DATE: 3/11/90
DRAWING OF WORK AS BUILT

RECORD DRAWING
OF WORK AS BUILT

Revisions as noted - As Built		Date	Approved
Revision	Description	Date	Approved
THE RBA GROUP Designed by: RBA Drawn by: JLB Checked by: JLB Submitted by: JLB Reviewed by: JLB Concurred by: JLB			
U.S. ARMY ENGINEER DISTRICT CORPS OF ENGINEERS NEW YORK, NEW YORK		SAWMILL RIVER, NEW YORK ARDSLEY FLOOD CONTROL PROJECT MIDDLE AREA FLOODPROOFING BUILDING ELEVATIONS	
Approval Recommended: JLB Approved by: JLB Concurred by: JLB		Sheet reference number: 32-100-100 Date: 20 JUL 90 Scale: AS SHOWN Sheet 32 of 40	NEW YORK 20 JUL 90

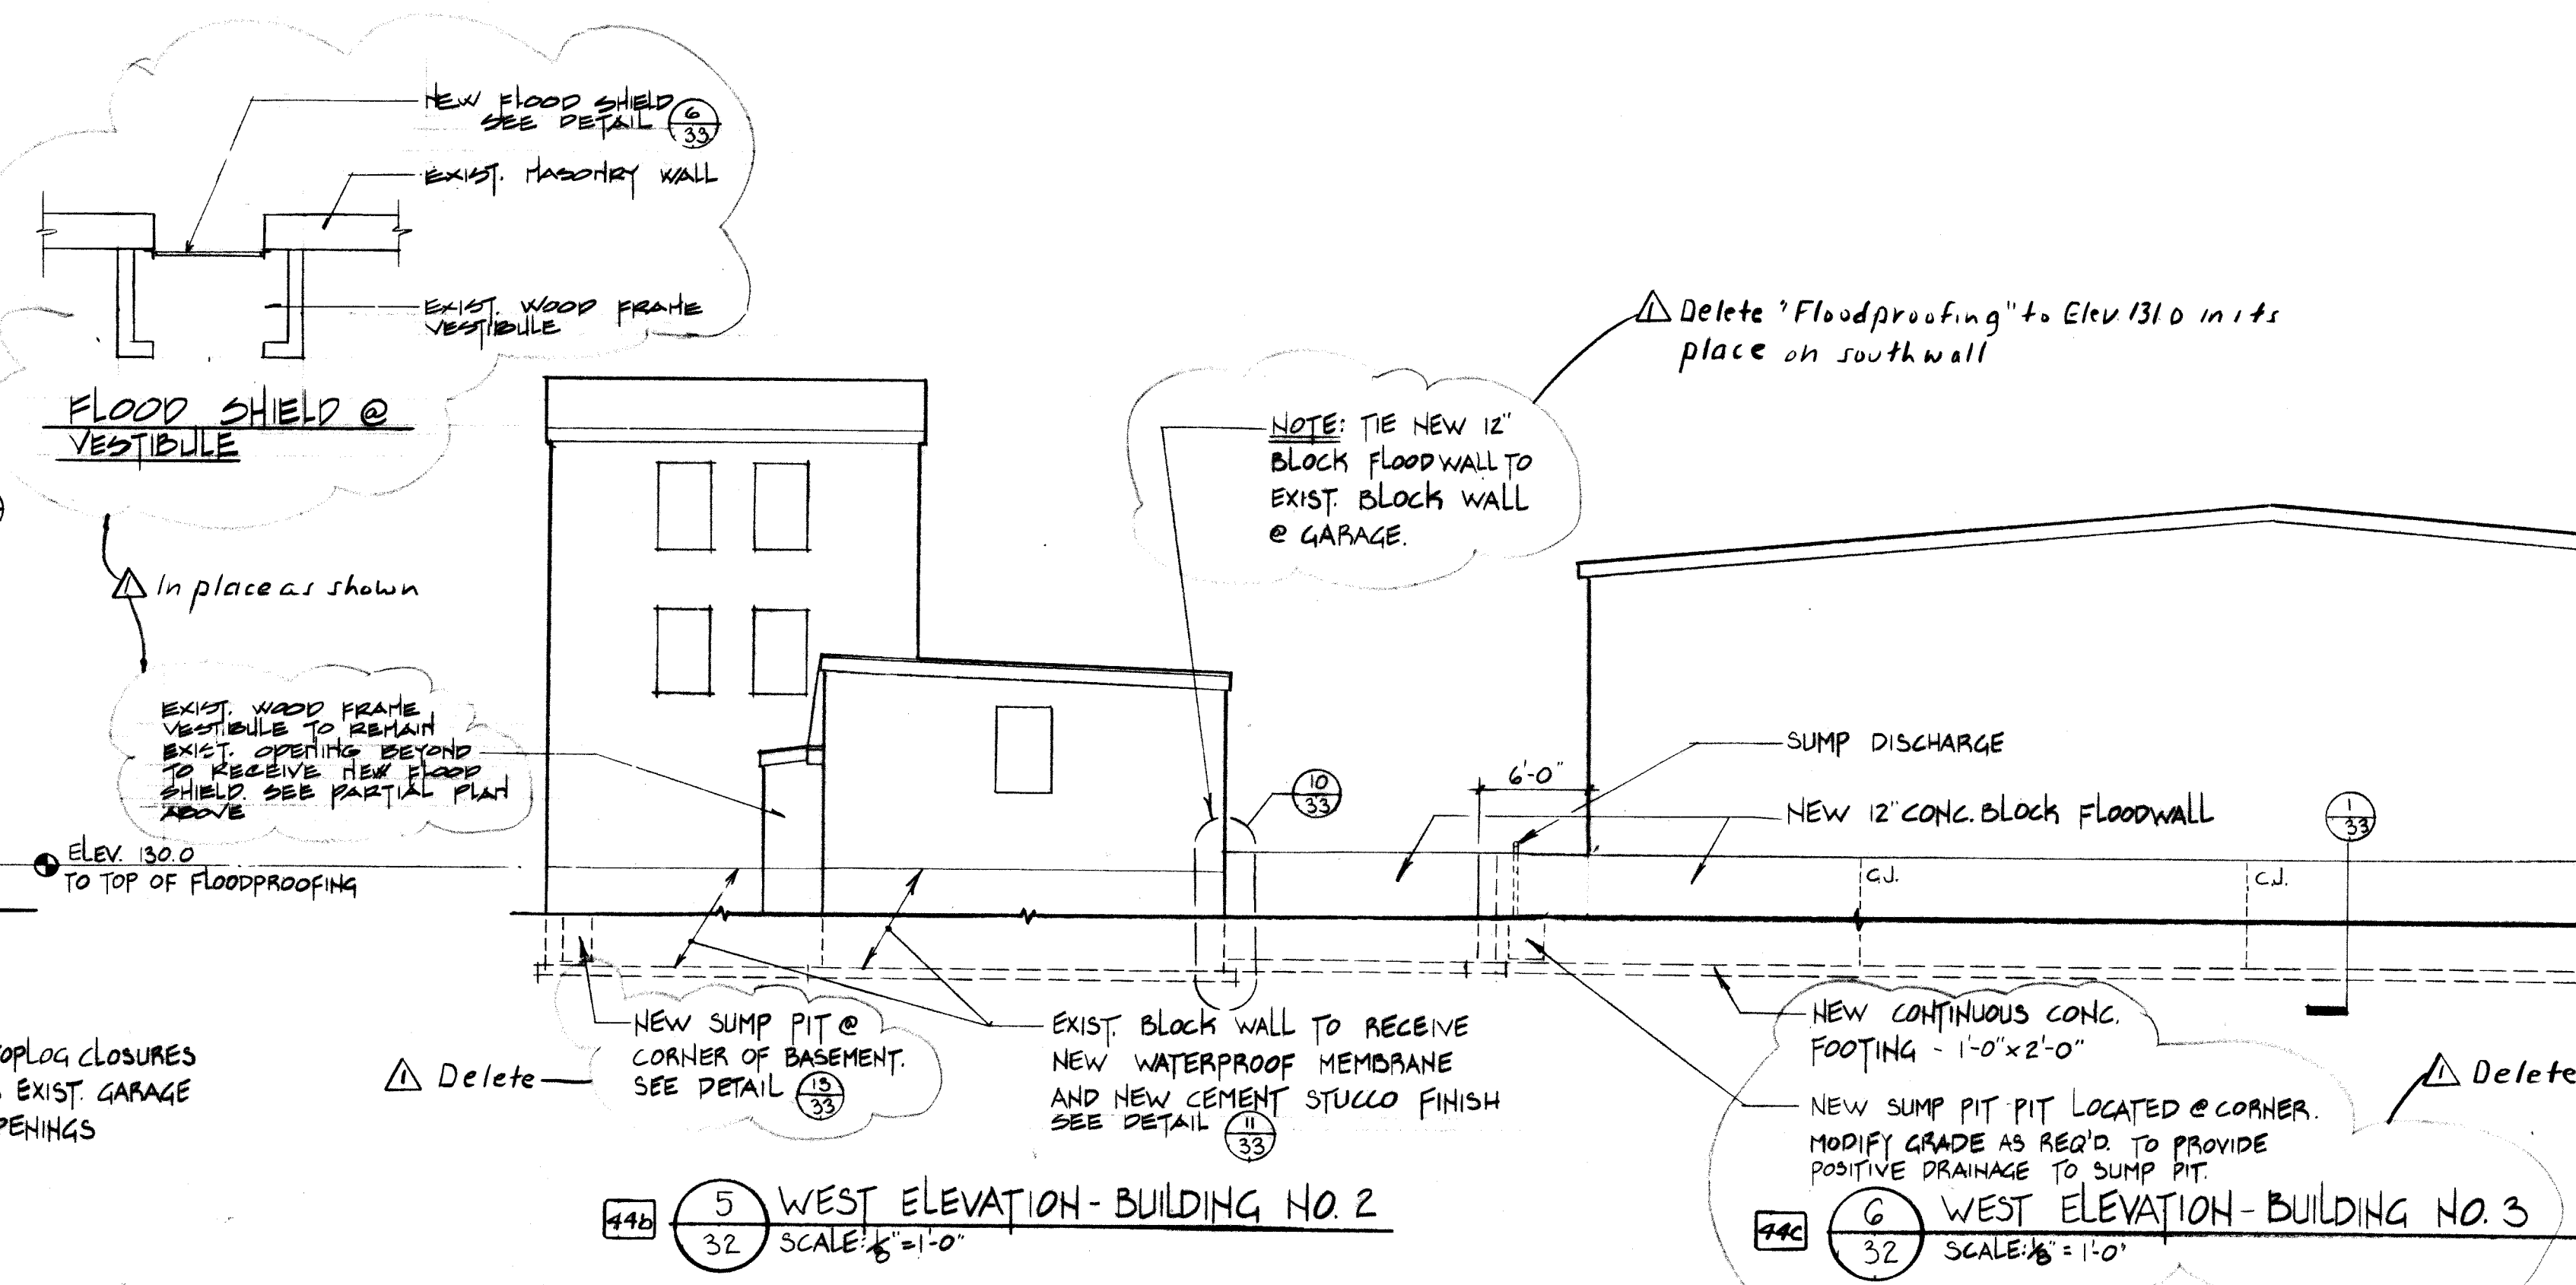
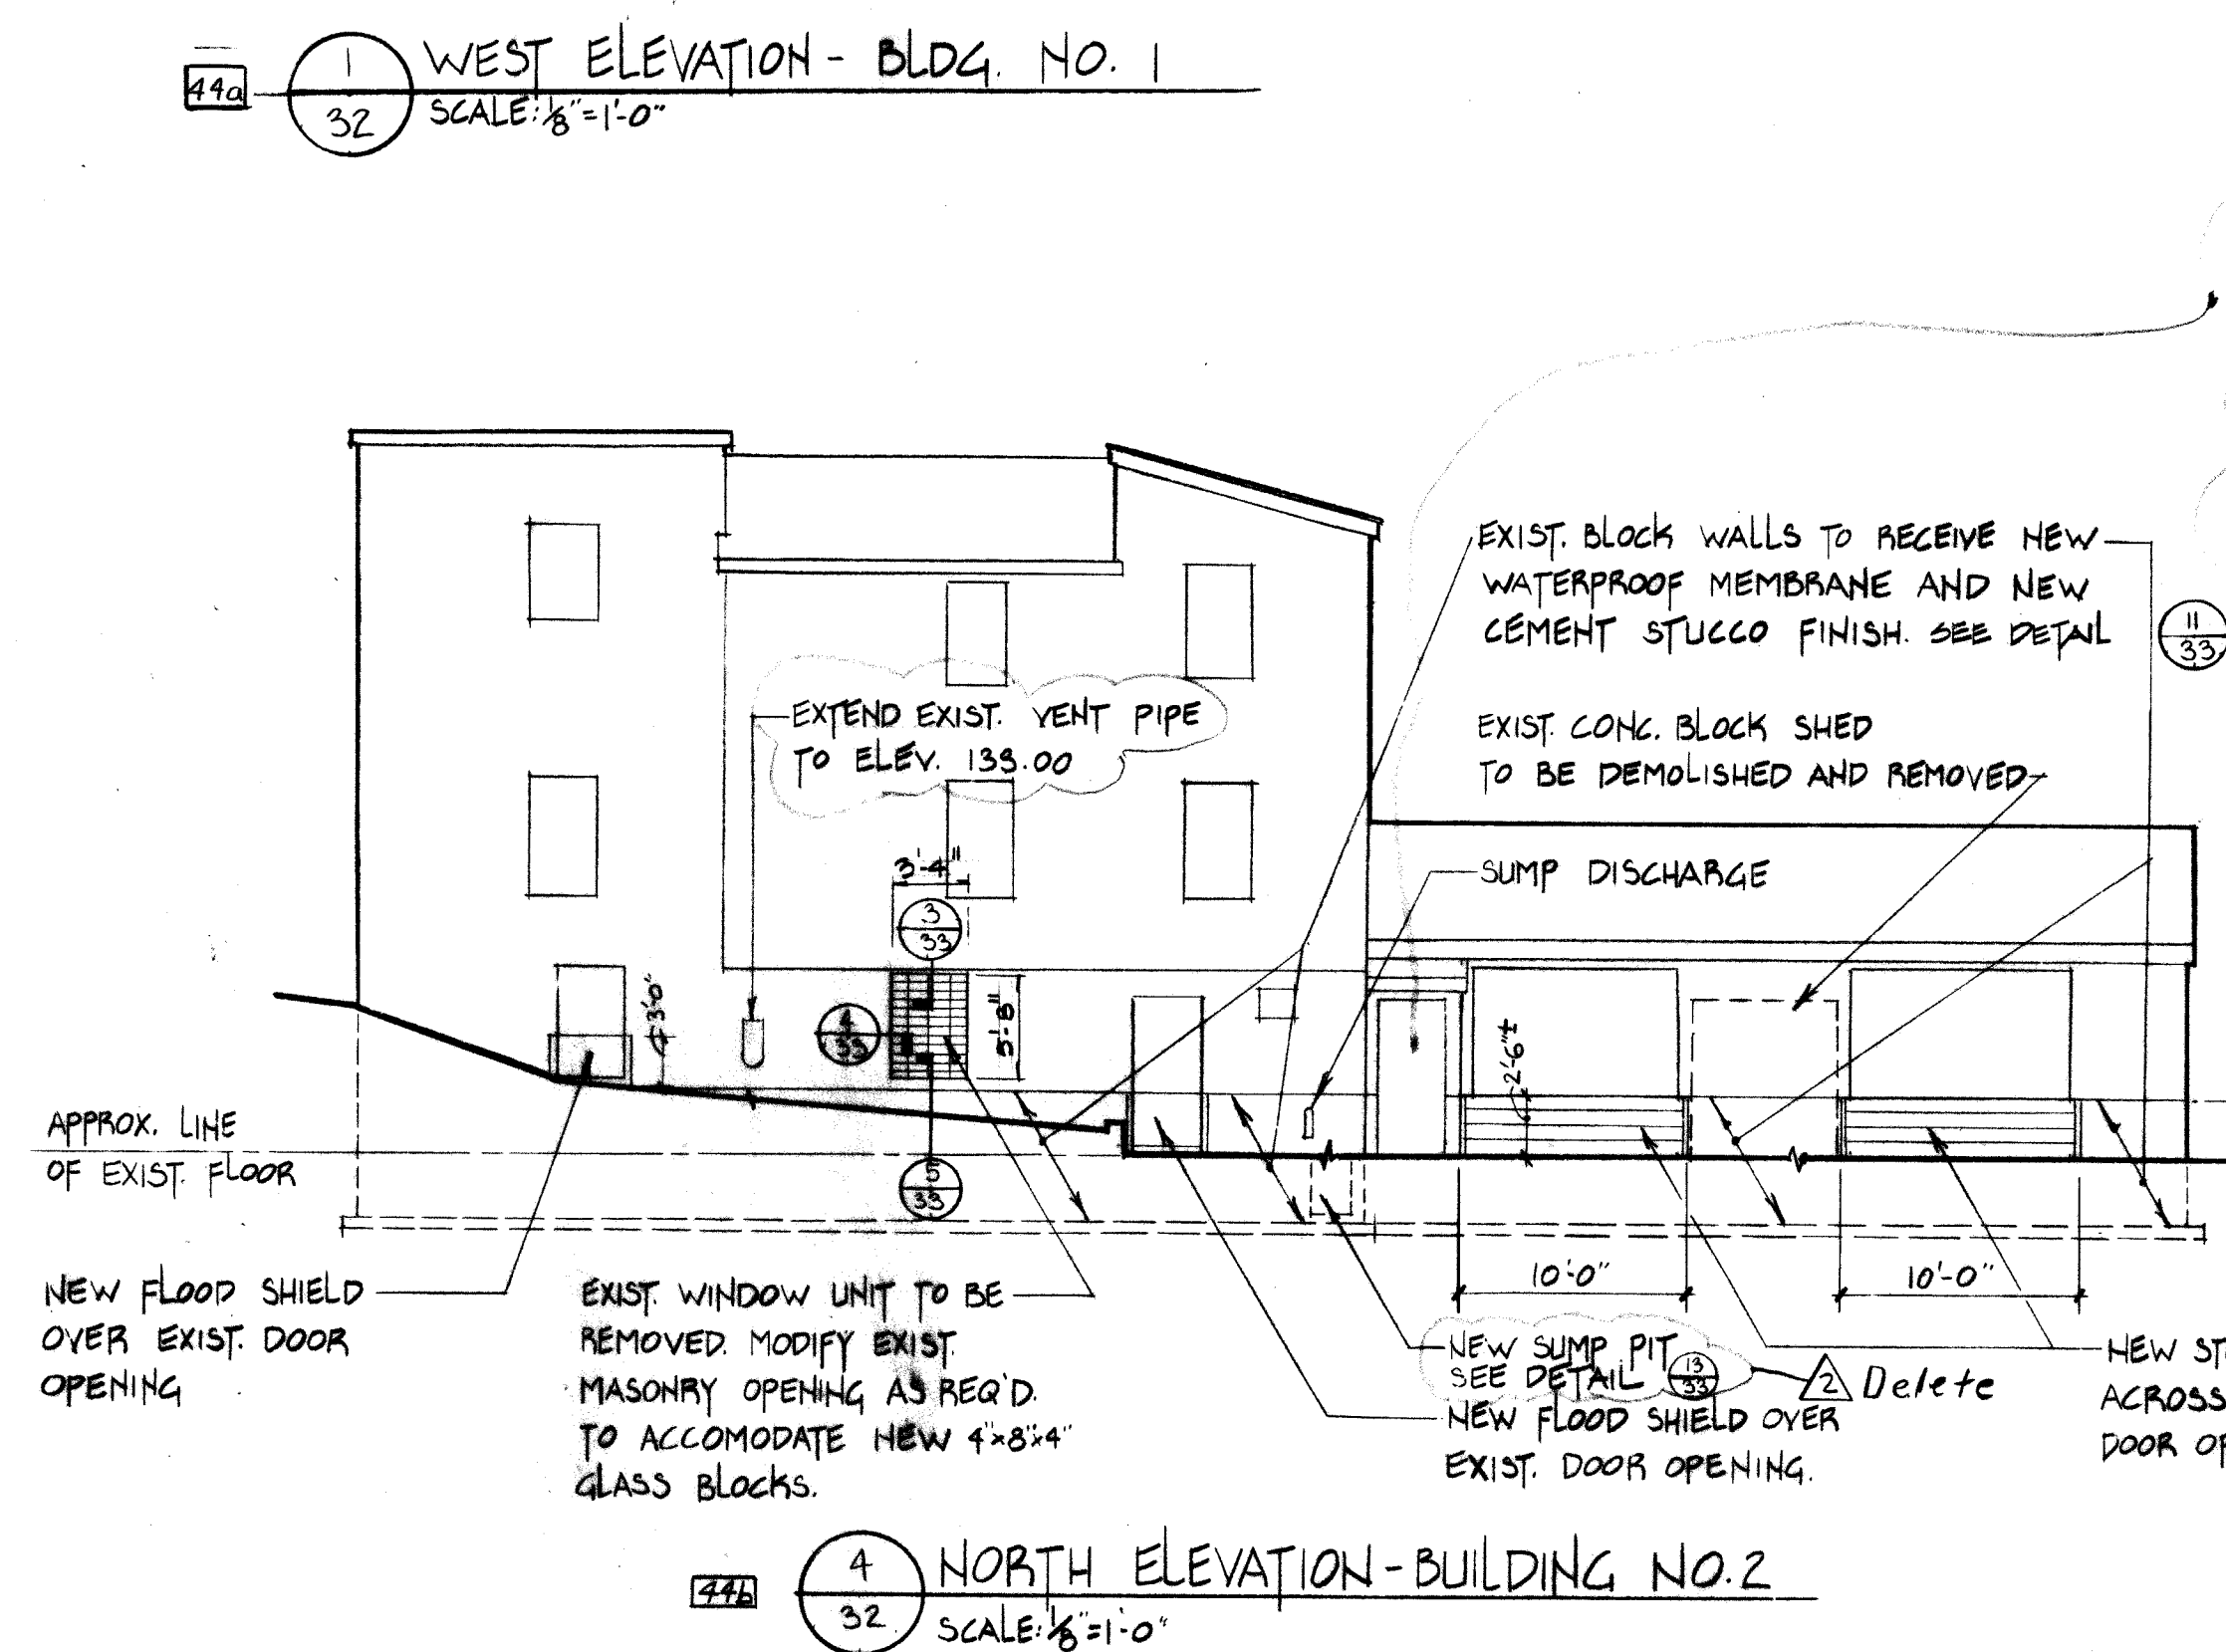
- Notes:**
- Work on Building No. 3 completely eliminated.
 - Building No. 1
 - No Stop Logs
 - No grouting along Perimeter of Stairs
 - Existing Drain Pipe to be rerouted
 - Sump to Storm Sewer piped underground
 - Delete New Sump Pit at Building No. 2. Waterproofing to South End of Building because Floodwall was deleted.
 - Building No. 4
 - New Floodshield to be eliminated
 - Stop logs must cross both Garage and Entrance. End stop logs at Garage Doors.
- Deleted due to Owner Improvements*
